**To:** Vince Carrica  
**Subject:** Unser pond details

**DEVELOPMENT REVIEW BOARD MEMO**

**DRB PROJECT NO: 1002632**

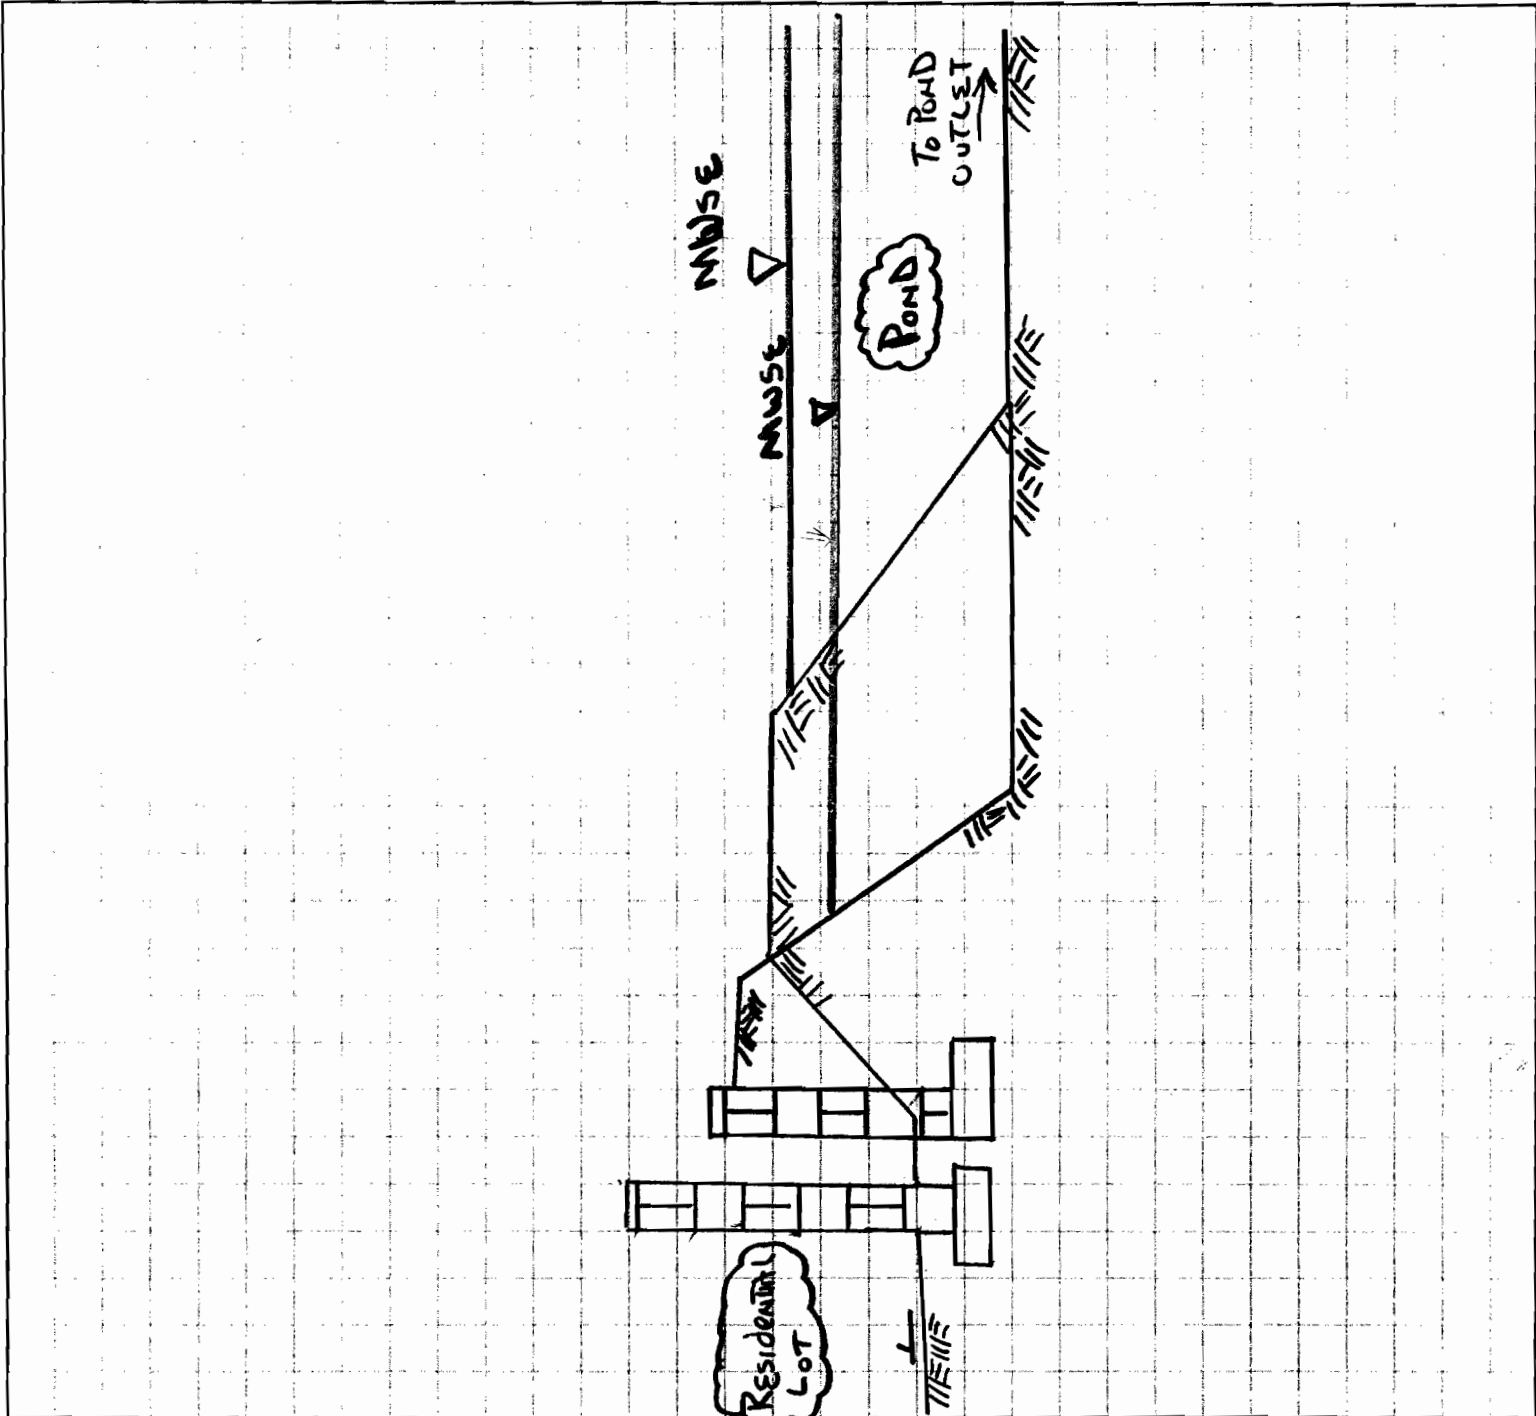
The wall on the east side of the pond is to be a continuous concrete floodwall-no block and be waterproofed. The top of footer as a minimum should be below the pond bottom and below the footer of the garden wall to the east. Is there a seepage concern that may affect existing structures?

There is a maintenance concern with the annulus between the walls. Wilfred says he needs at least 6.5 feet to get a skid steer in there. Or the area could be capped so there is no annulus.

As mentioned earlier, the detail of this area is to be on the Grading Plan.
